BID ADDENDUM #6

**Nanuet Union Free School District
103 Church Street
Nanuet, NY 10954**

Nanuet Bond Projects Phase 3

Date: July 12, 2023

BM-A121

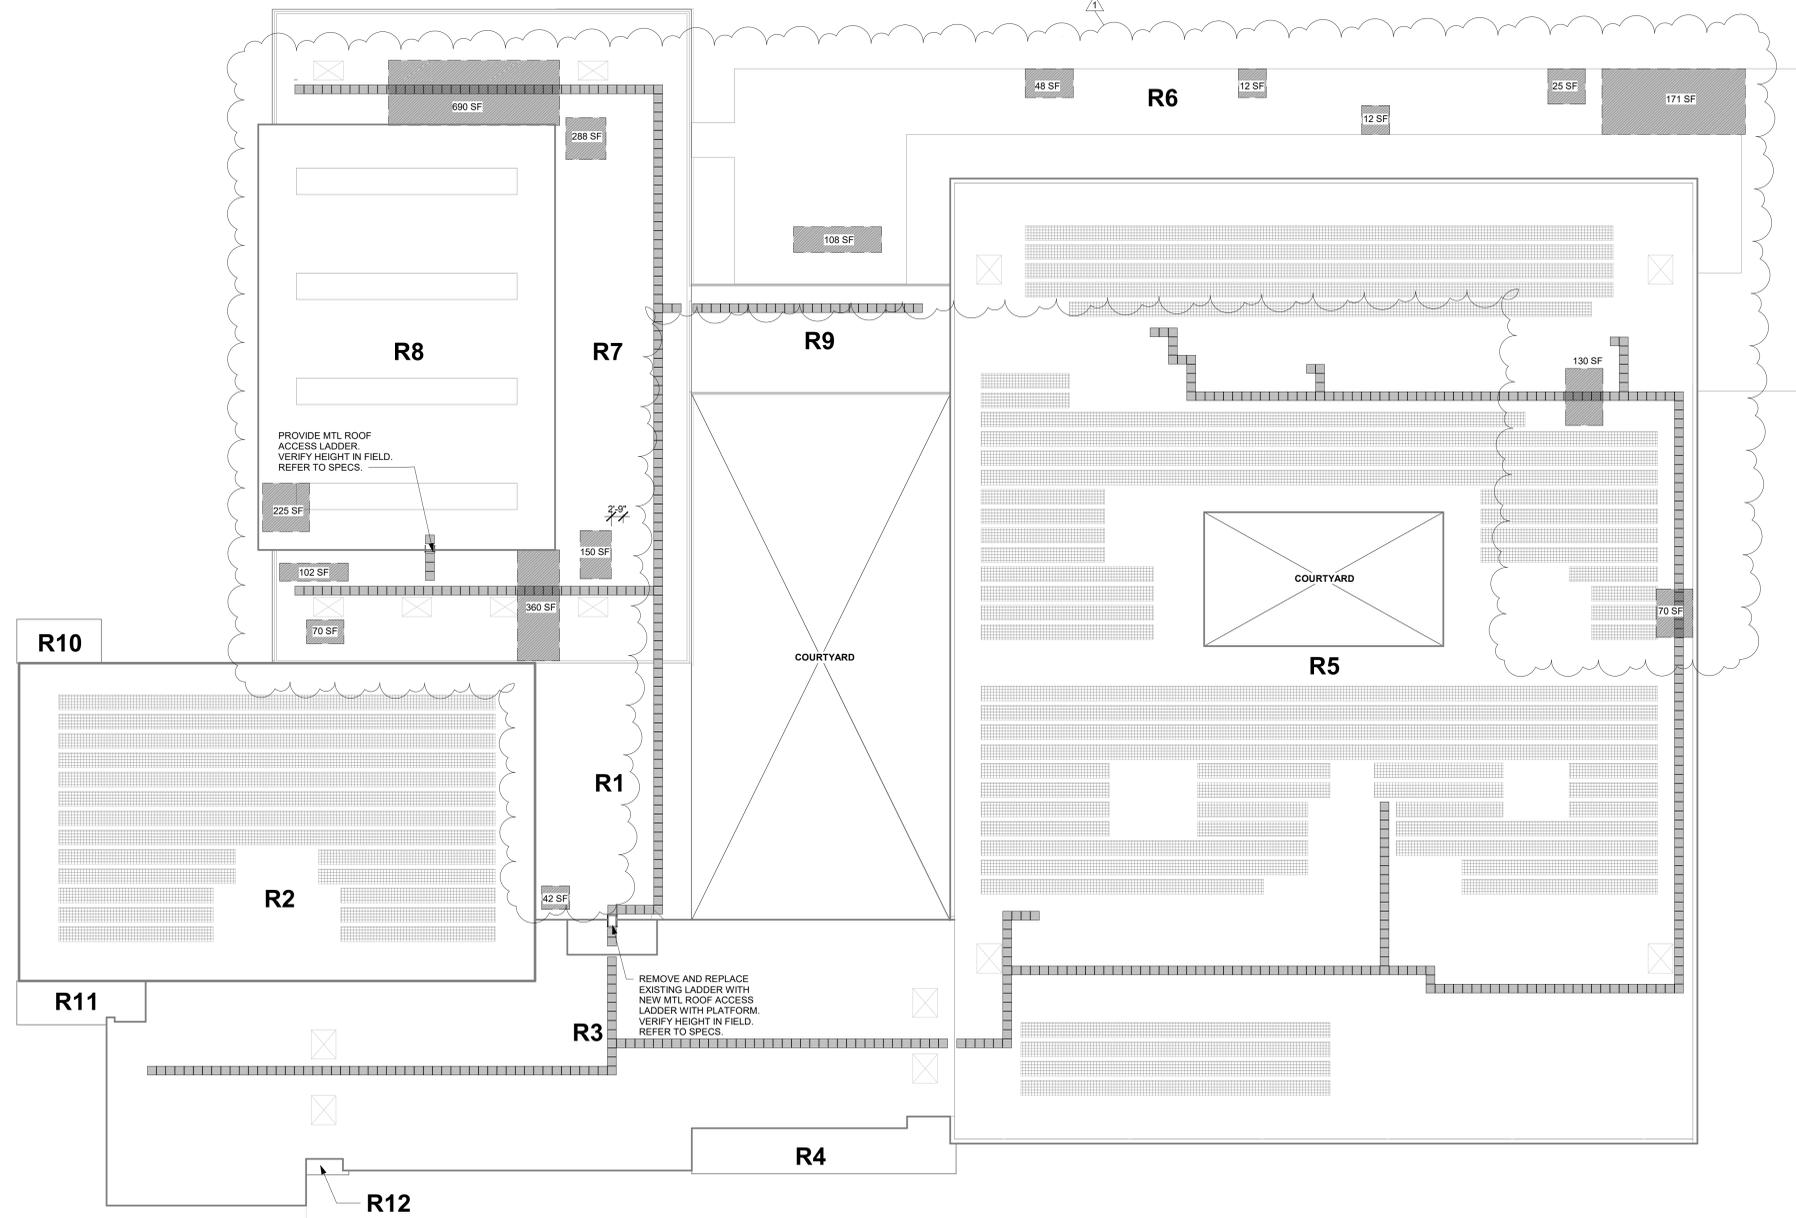
1. **BM-A121**
 - a. Drawing updated approximate wet areas of insulation to be removed.
2. **HS-A121**
 - a. Drawing updated approximate wet areas of insulation to be removed.

WET AREA NOTES

- REMOVE AND REPLACE AREAS OF IDENTIFIED AS WET INSULATION FROM THE FINALIZED MOISTURE SURVEY.
- REMOVE MEMBRANE AND WET INSULATION DOWN TO THE ROOF DECK AT EXISTING ROOF TYPE (A)
- INSTALL NEW INSULATION TO MATCH THE HEIGHT OF THE EXISTING INSULATION. APPLY ADDITIONAL LAYERS AS NEEDED TO REMOVE ANY PONDING AREAS AT EXISTING ROOF TYPE (A)
 - ADHERE INSULATION AND COVER BOARD TO EXISTING DECK IN LOW RISE FOAM INSULATION ADHESIVE
- AT EXISTING ROOF TYPE (A) INSTALL NEW TWO-PLY SBS-MODIFIED MEMBRANE ROOF REPAIR PATCH ADHERED IN POLYURETHANE ADHESIVE AND TIE INTO THE EXISTING ROOF
- ALL NEW ROOFING INSULATION IS TO BE PROVIDED BY BUILDING ENVELOPE CONTRACTOR.

BM-M105

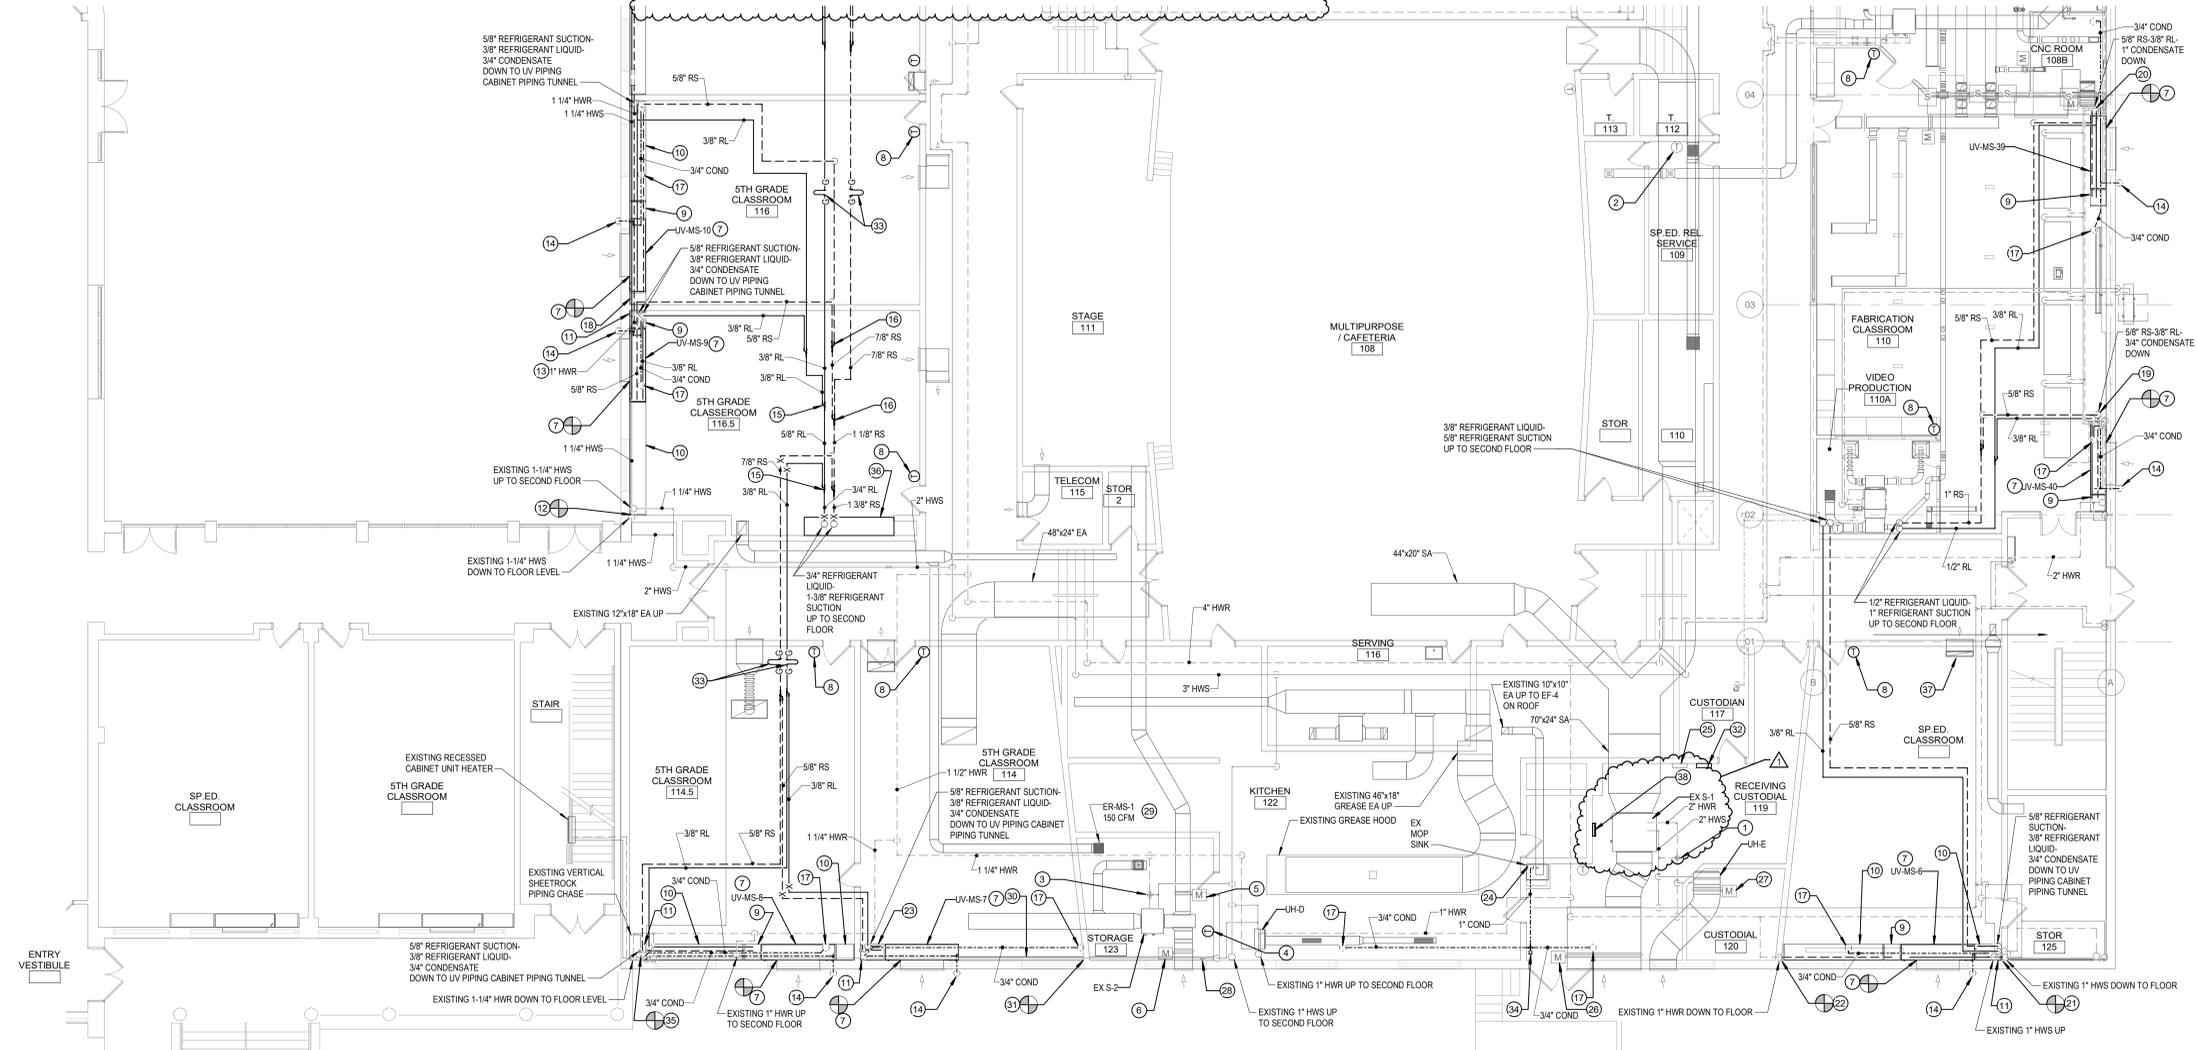
- a. Regarding Pneumatic control demo: would it be acceptable to cap open/obsolete pneumatic tubing, remove obsolete pneumatic tubing where exposed to view, and abandon in-place pneumatic tubing that is concealed or in otherwise inaccessible areas or above access from a 10 ft ladder height?

Response: Refer to revised Mechanical drawings BM M104-M108 and HS M103-105 that clarify the pneumatic tubing removal requirements
 - b. Regarding electronic control wiring demo: would it be acceptable electrically isolate the wiring on both ends and leave the wiring abandoned in-place when bundled with other active wiring or routed in concealed or in otherwise inaccessible areas or above access from a 10 ft ladder height?

- REGARDING PNEUMATIC CONTROL SYSTEM REMOVAL WORK: CAP OBSOLETE PNEUMATIC TUBING AT ALL LOCATIONS. REMOVE OBSOLETE/DISCONNECTED PNEUMATIC TUBING WHERE EXPOSED TO VIEW. ABANDON IN-PLACE PNEUMATIC TUBING THAT IS CONCEALED OR IN OTHERWISE INACCESSIBLE AREAS.

BM-M112

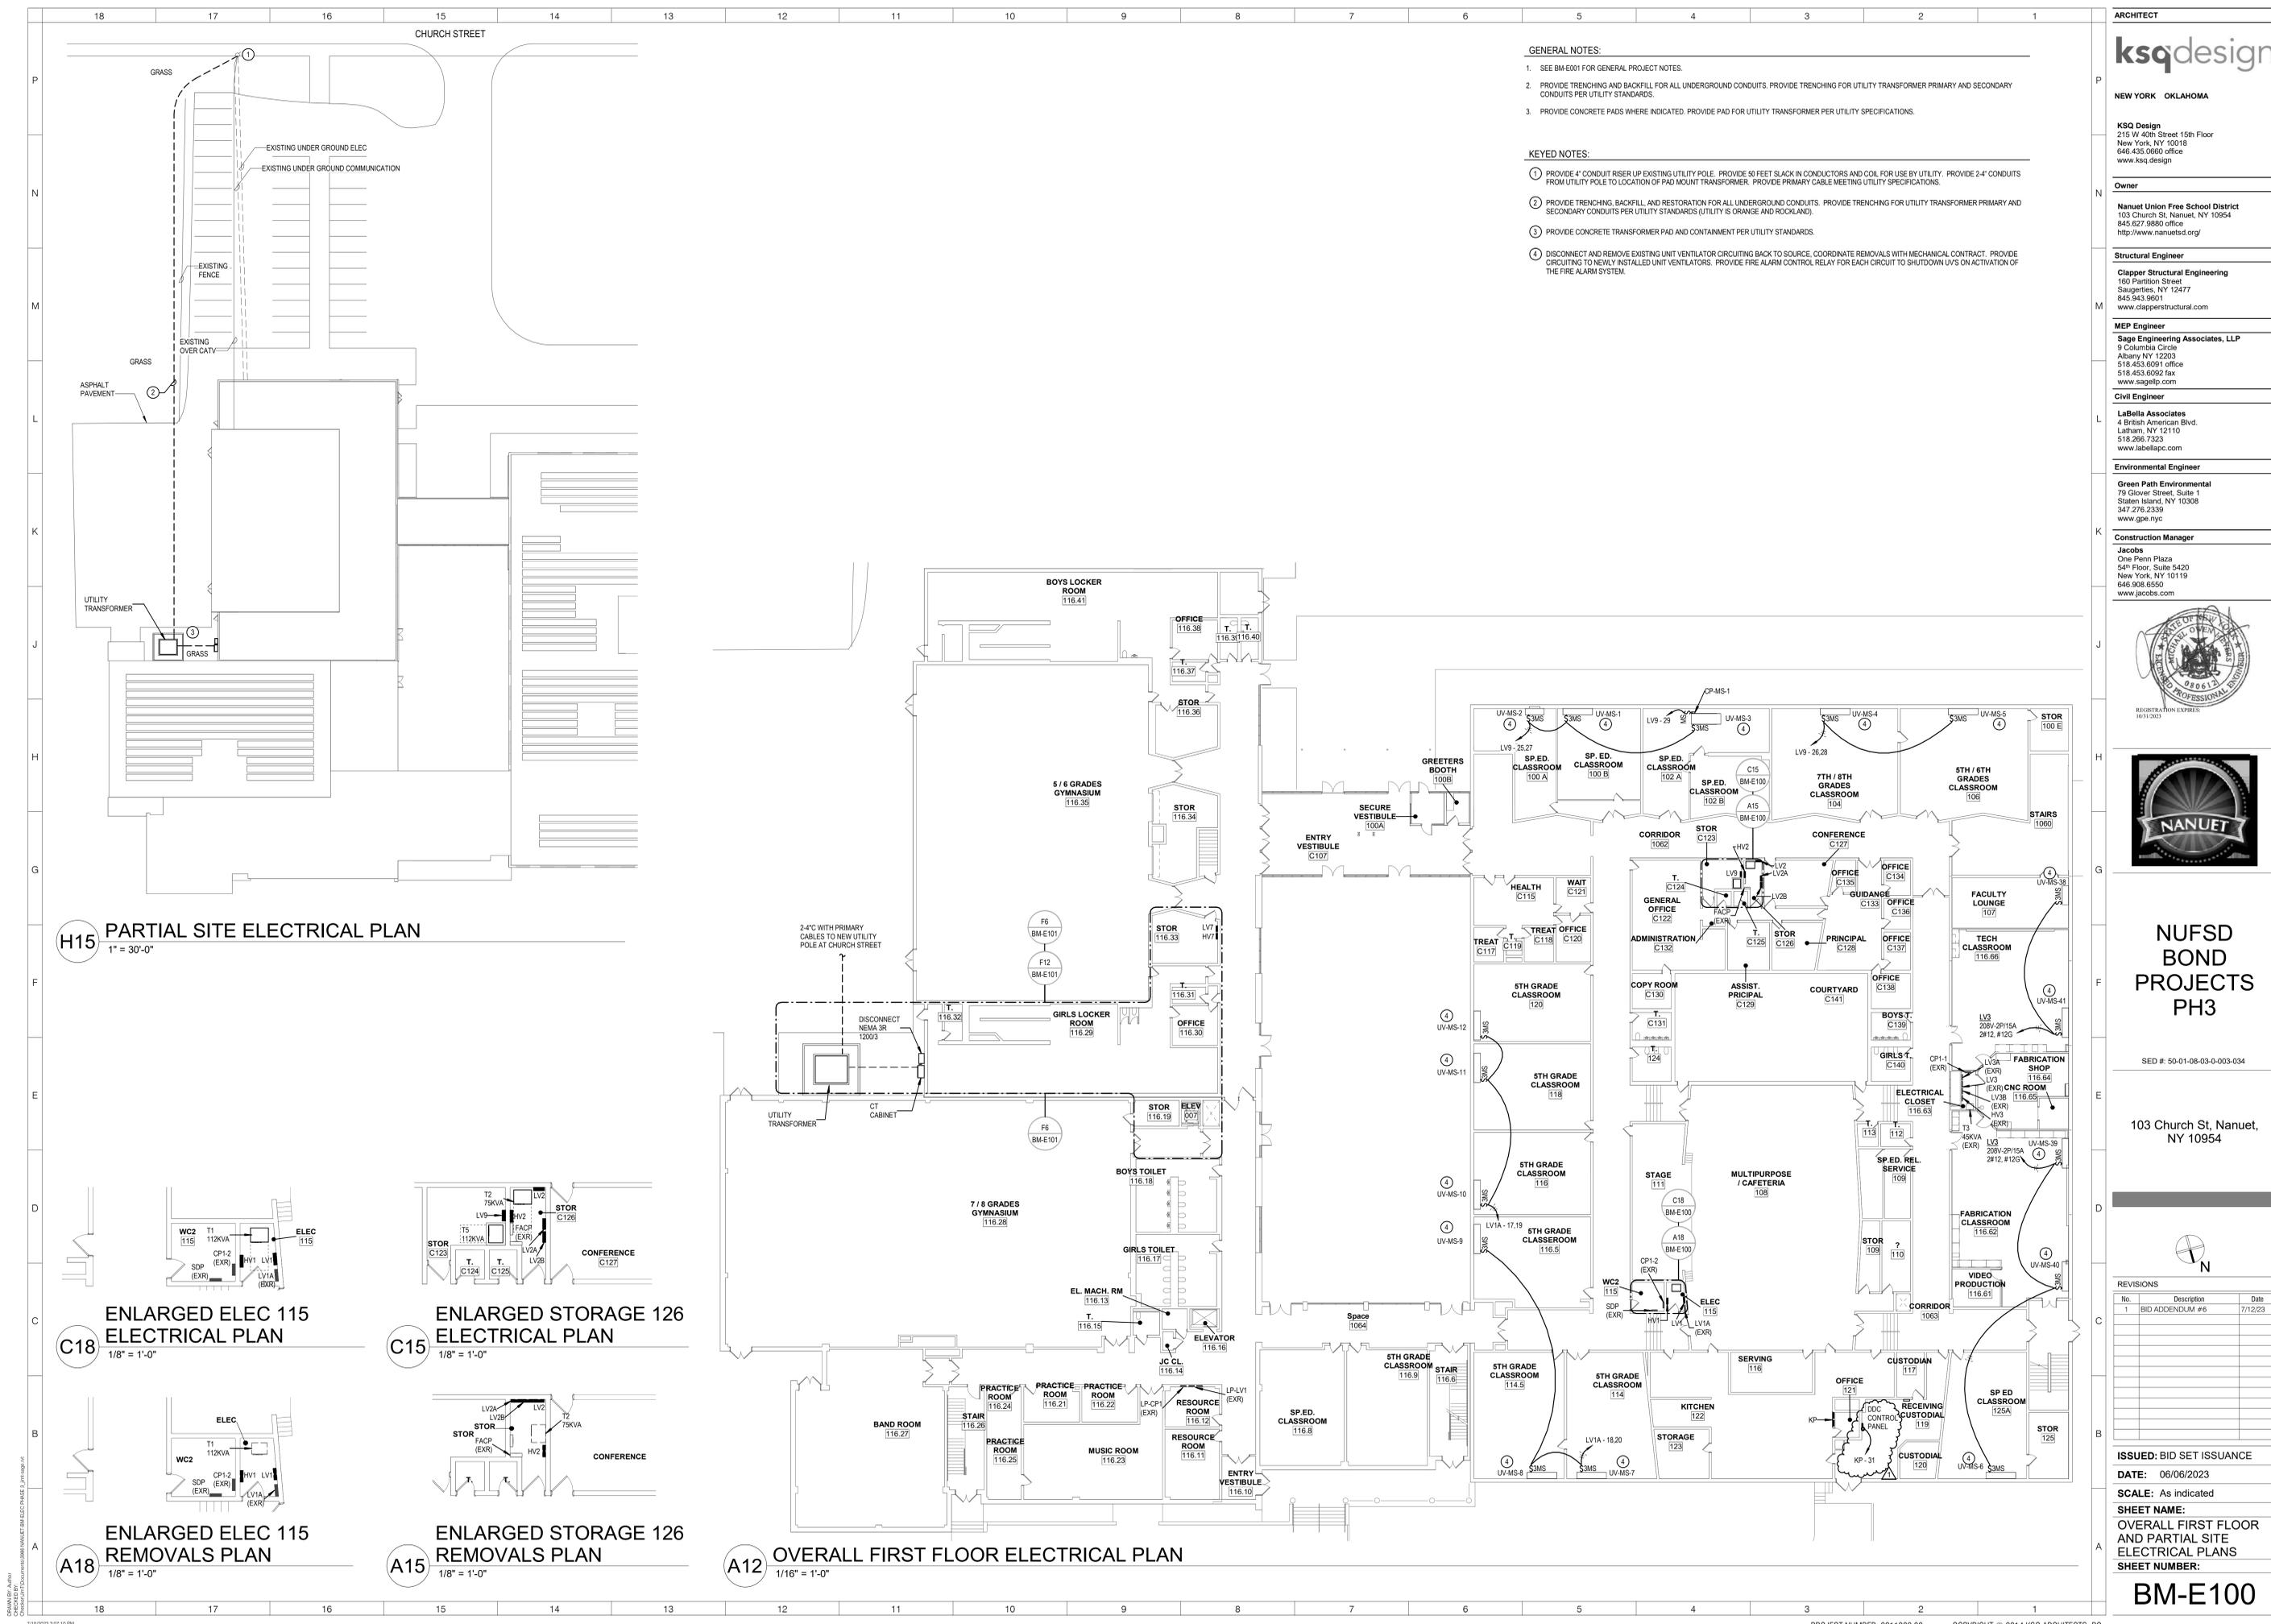
- c. Include Installation of new BAS panel and enclosure for the 1st floor, Room 119, BM-M112.
Response: Refer to revised Electrical drawings for the powering of the Siemens requested DDC panels.

- PROVIDE DDC SYSTEM CONTROL PANEL ENCLOSURE AT LOCATION SHOWN TO HOUSE DDC CONTROLLERS, TRANSFORMERS, RELAYS, AND REQUIRED DDC SYSTEM COMPONENTS TO ACCOMPLISH THE SPECIFIED SEQUENCES OF OPERATIONS.
